SERVICE BULLETIN

DATE: 24 MAY 1996

LATERAL ANTI-TORQUE – DRIVE LINK ASSEMBLY REPLACEMENT

Figure 1. Cyclic Centering Decal Repositioning

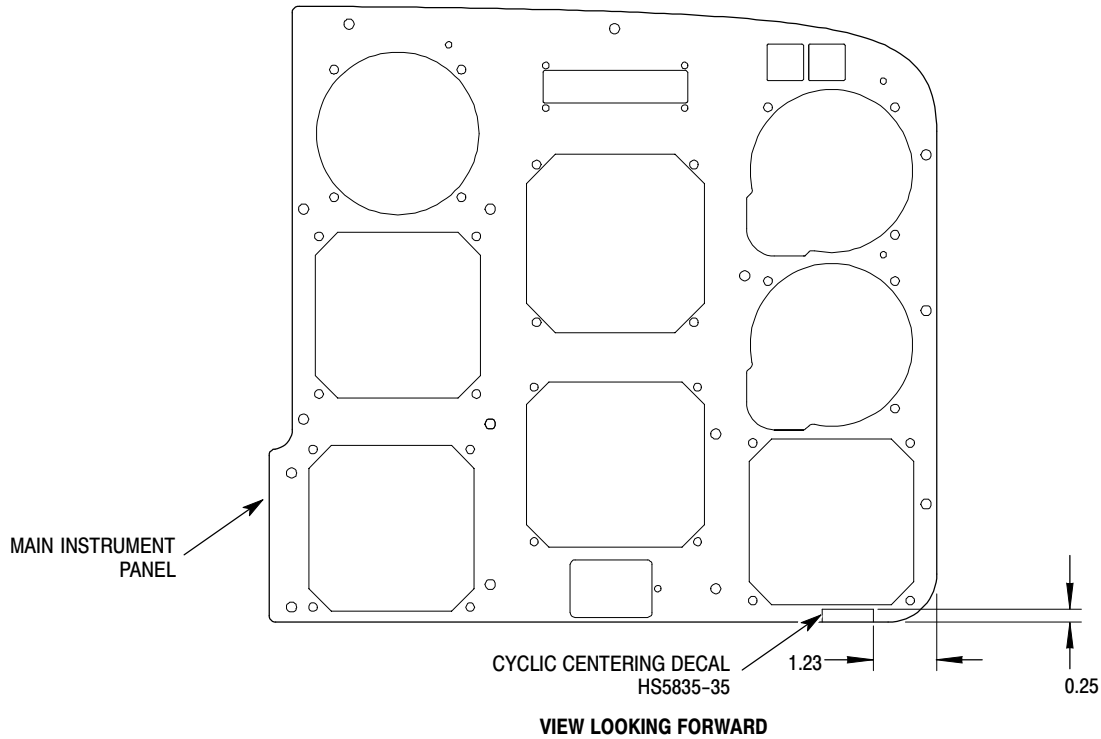
Procedures in this Bulletin provide operators with instructions to exchange their existing lateral link assembly 900C2010209-103 with a 900C2010209-105 or a 900CF010210 link assembly. This procedure also provides instructions to reposition the cyclic control centering decal, P/N HS5835-35.

- (2). Remove cyclic centering decal HS5835-35.
- (3). Install lateral anti-torque - drive link assembly 900C2010209-105 or 900CF010210 per instructions in the Rotorcraft Maintenance Manual (CSP-900RMM-2; Ref. Section 62-30-00).
- (4). Install cyclic centering decal HS5835-35 per instructions contained in the Rotorcraft Maintenance Manual (CSP-900RMM-2; Ref. Section 11-00-00) except locate as shown in Figure 1 of this Bulletin (ref. Page 3 of 3).
- (5). Perform a controls sweep check with a visual inspection of the rotating controls components above the mixer assembly to insure no interference was observed.
